Land-Rover Service Newsletter Vol. 3 No. 25

July 1971

The Rover Company Limited Service Department: Solihull, Warwickshire, England

Fig. 1 Piston identification
A—Piston crown date stamped

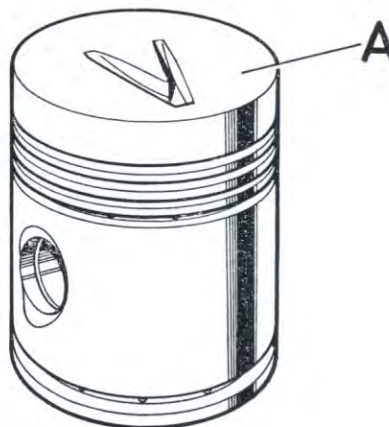
MODIFICATION: Increased grading of piston to cylinder bore clearance.

IDENTIFICATION: All pistons date-stamped D70 onwards comply with this increased grading. (D.70 = April 1970, E.70 = May 1970 etc.).

REMARKS: To minimise piston seizure, there has been a modification to increase the tolerance of the piston to cylinder bore clearance by 0,010 mm (.0004 in.) but there has been no alteration in part number.

Distributors and Dealers involved in investigating cases of piston seizure should check the date-stampings on the piston crowns before taking any action.

If the date of manufacture was later than April 1970, then Product Investigation Section of Technical Service Department should be advised immediately.

Fig. 2 Starter pinion and sleeve

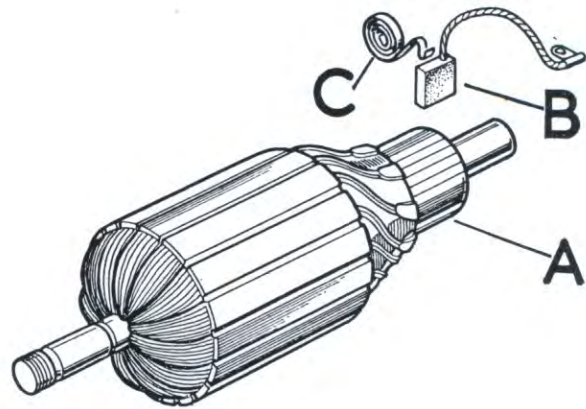
- Item 149** SUBJECT: **PINION AND SLEEVE FOR STARTER MOTOR**
- MODELS: Land-Rover Series I, II and IIA, Bonneted and Forward Control, Petrol.
- MODIFICATION: Deletion of additional items previously supplied.

- PART NUMBER: Pinion and sleeve for starter motor 1 244711
- REMARKS: Only the pinion and sleeve for starter motor is now supplied under Part No. 244711; the bush for the pinion end, spring for pinion, and 2 collars have been deleted.

- There has been no change in part number, and when existing stocks are exhausted only the latest part will be supplied for Service replacements.
- Distributors and Dealers are requested to amend their records accordingly.
